## Executive Director's Recommendation

<b>PROJECT</b> <b>President Franklin D. Roosevelt Prayer Plaque</b> World War II Memorial The National Mall Washington, DC	<b>NCPC FILE NUMBER</b> 7727
<b>SUBMITTED BY</b> United States Department of Interior National Park Service	<b>NCPC MAP FILE NUMBER</b> 00.00(73.10)44461
<b>REVIEW AUTHORITY</b> Per 40 U.S.C § 8905 and Public Law 113-123	<b>APPLICANT'S REQUEST</b> Approval of comments on concept design
	<b>PROPOSED ACTION</b> Approve comments as requested
	<b>ACTION ITEM TYPE</b> Staff Presentation

# NCPC File 7727: President Franklin D. Roosevelt Prayer Plaque

Alternative I: Three Panel plaque

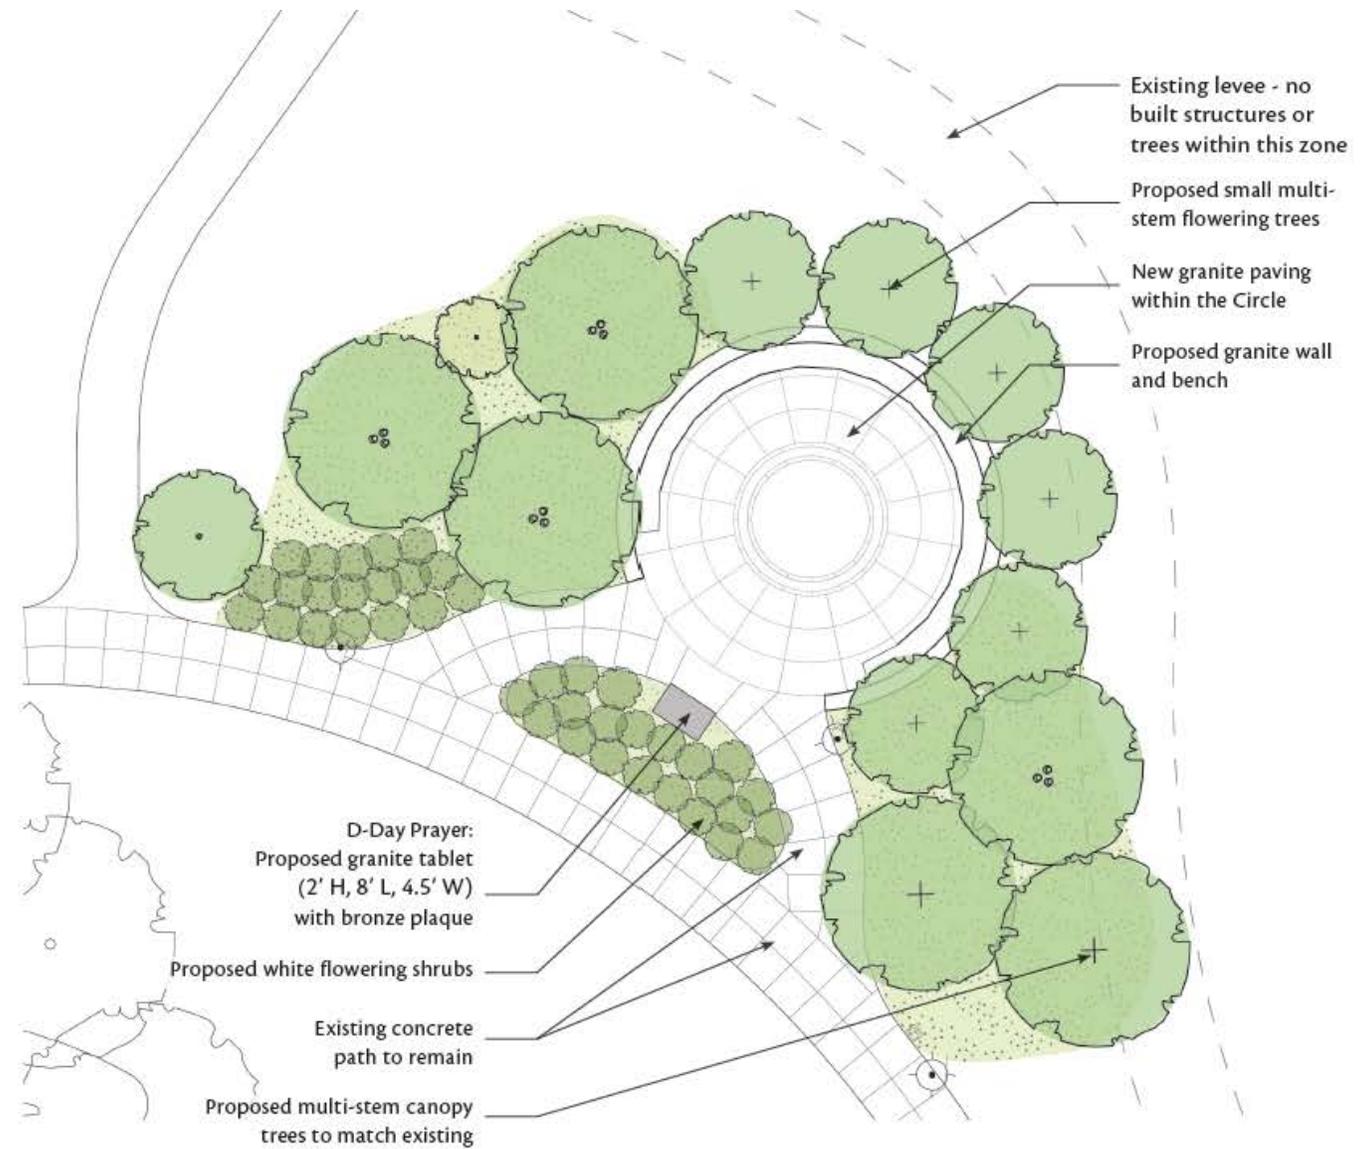
This alternative locates a nearly square (4' tall, 5' wide), free-standing bronze plaque within the existing vegetative planter at the entry to the Circle of Remembrance. The plaque and granite tablet with the following dimensions: 2' tall, 4.5' wide, and 8' long, would be located at shallow angle close to the ground and projecting toward the center of the planter. This alternative does not alter the existing circulation and visitation patterns. Visitors could read the plaque inscription from the sidewalk adjacent to the existing planter. However, the low height and configuration of the plaque could inhibit legibility.

Alternative II: Four Panel plaque

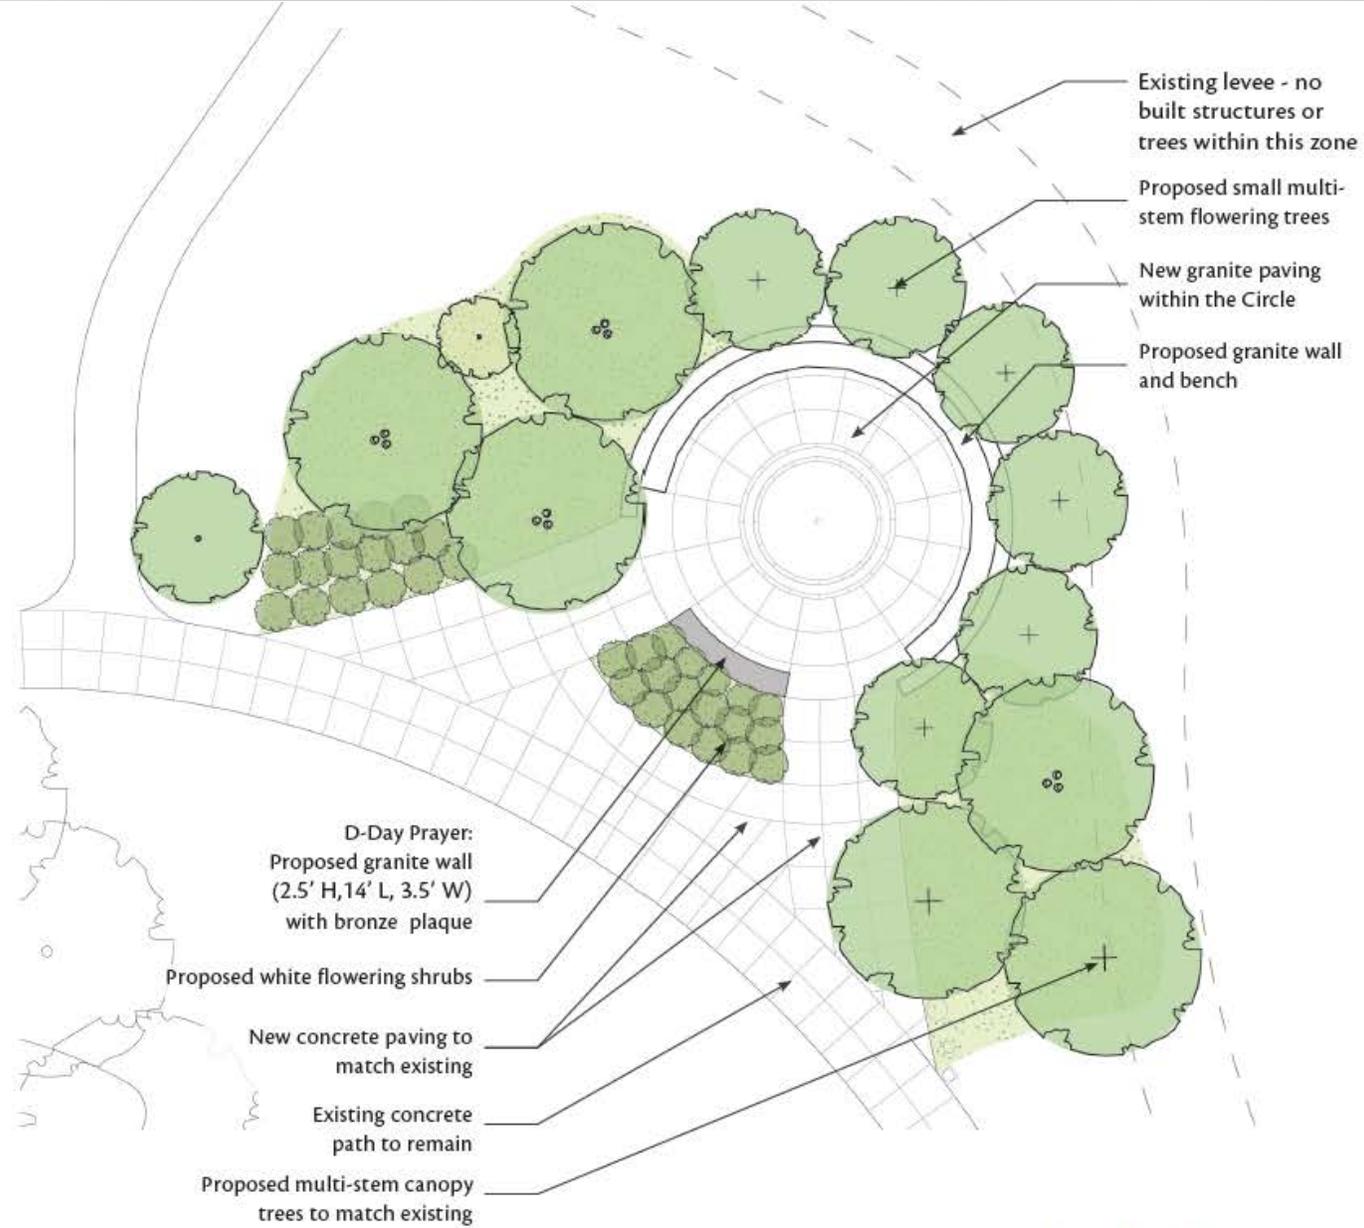
**Supports** Alternative II, at the edge of the Circle of Remembrance, as the preferred location and design of the President Franklin D. Roosevelt prayer plaque.

**Notes** that Alternative II completes the geometric form of the circle while incorporating the plaque as a free-standing element, separated from the circular wall enclosure by two pedestrian pathways.

This alternative locates a rectangular (3' tall, 9' wide), free-standing bronze plaque at the edge of the Circle of Remembrance. The plaque and granite wall with the following dimensions: 2.5' tall, 3.5' wide, and 14' long, would be located at the edge of the Circle of Remembrance and conform

to the geometry of the circle. The bronze plaque and curved granite wall would be separated from the circular retaining wall and benches by two pedestrian pathways. This alternative slightly alters the existing circulation and visitation patterns. The sidewalk leading to the entry of the Circle of Remembrance would be widened and the existing planting area would be reduced and shifted westward to aligned with the outside edge of the circle and curved granite wall. Visitors could read the plaque inscription from within the Circle of Remembrance. This alternative integrates the addition of the free-standing plaque in a manner that is geometrically and materially related with improvements to the Circle of Remembrance.

Staff notes that a program for the plaque has not been defined and that the applicant should consider what types of ceremonies, services, or events might be planned and how much visitation the plaque or inscription will receive once it is in place. However, staff recommends that Alternative II is the best location and design for the FDR prayer because it formally and materially integrates the prayer plaque with the Circle of Remembrance, it complies with the original WWII design intent, and it allows the D-Day prayer to be read comfortably from a standing position.

**Recommends** that the sponsor continue to refine the design of the prayer plaque, ensuring that the plaque is:

- complementary in scale and material with the proposed retaining wall and benches encompassing the Circle of Remembrance.
- formed with a height and size that promotes legibility while discouraging unintended uses such as sitting or sleeping.
- made of a material and color that harmonizes with the surrounding landscape context.
- planted with adjacent vegetation that promote long-term legibility and ease of maintenance.
- located to protect existing views to the National Mall, including views to the World War II Memorial primary precinct, the Washington Monument, and Constitution Gardens.
